SUBJECT: Explanation of Significant Differences for the Richardson Hill Road Landfill Superfund Site

Explanation of Significant Differences

RICHARDSON HILL ROAD LANDFILL SITE

Towns of Sidney and Masonville
Delaware County, New York

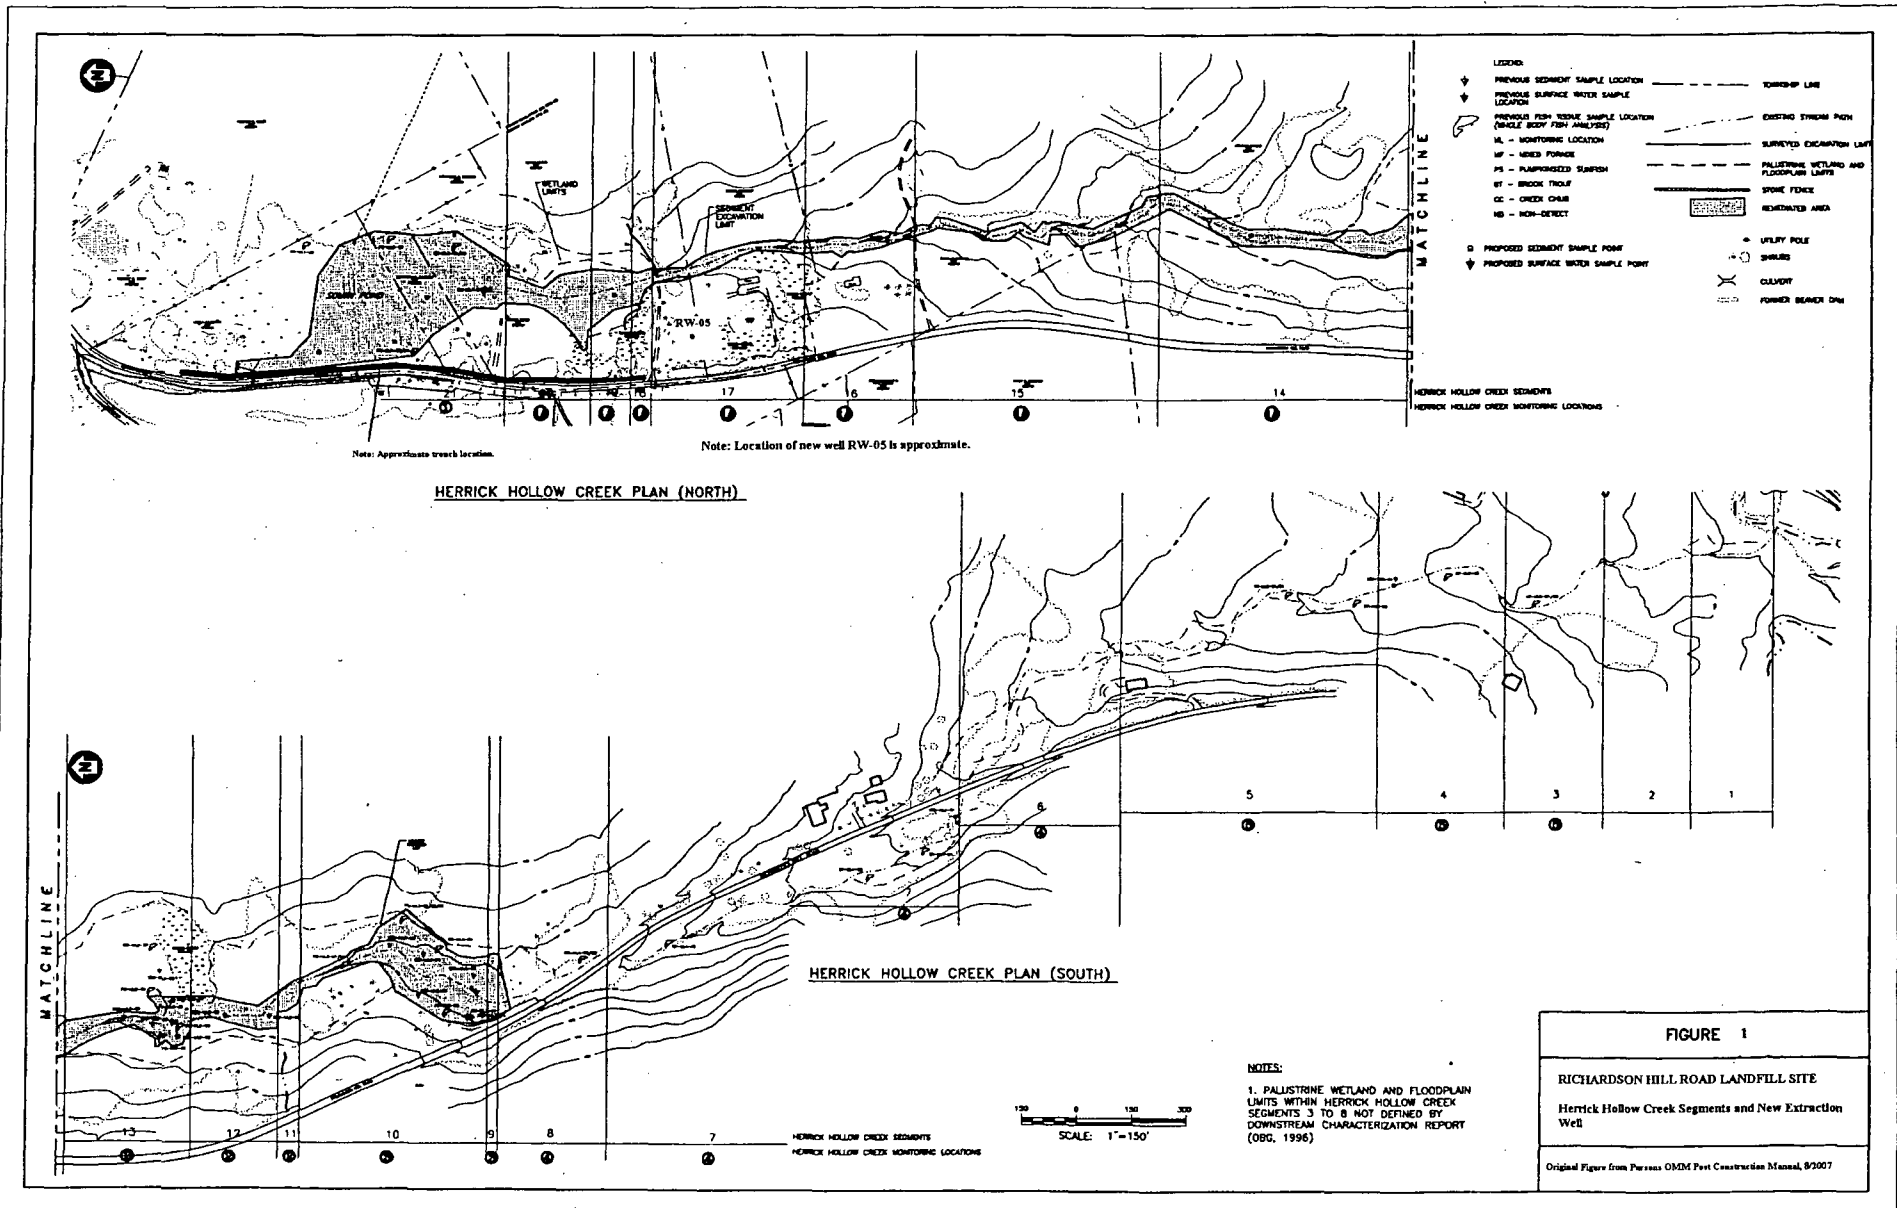
The ROD calls for the excavation and/or dredging of sediments exceeding 1 milligram/kilogram of PCBs from South Pond and Herrick Hollow Creek downstream for approximately 2,400 ft. (Segments 21 to 14 on Figure below). The ROD also stated that the need for remediation in areas further downstream (i.e., Segments 13 to 9) would be evaluated based on an assessment of sediment, surface water, and biological receptors over the 5-year time period subsequent to the completion of upstream remediation activities. Further remediation would be required in Segments 13

During the design investigation in 2002, in consideration of the possibility that the PCB-contaminated sediments in Segments 13 to 9 would still need to be removed in the future after years of monitoring, the option of removing these sediments concurrent with the removal of sediments in Segments 21 to 14 was evaluated. Based upon this evaluation, it was determined that if this approach was taken, not only would the potential benefits of the remedy be realized sooner, but cost savings associated with only one mobilization of equipment and the elimination of the long-term monitoring related to all of the contaminated sediments once they are removed, would also be realized. In addition, the Settling Defendants were willing to undertake the additional sediment removal work at that time. As a result, EPA and NYSDEC decided to remove the contaminated sediments in Segments 13 to 9 concurrently with the contaminated sediments in Segments 21 to 14.

The ROD also calls for groundwater extraction via a collection trench located immediately upgradient of South Pond and recovery extraction wells in the North Area, followed by treatment. Beginning in 2006, the fate and transport of the groundwater contaminants found to the east and south of South Pond was investigated. The study (*Supplemental Hydrogeologic Investigation Report*, O'Brien & Gere, September 2008) concluded that although the extraction trench shows some influence in this area, the trench alone will not result in contaminant levels in this area reaching groundwater standards in a reasonable time frame. To address this contamination, the groundwater in this area will be extracted from a new well located southeast of the trench and treated at the existing treatment facility. To protect the nearby wetland from dewatering, the groundwater will be extracted at a low rate and on an intermittent basis.

Note: Approximate trench location.

Note: Location of new well RW-05 is approximate.
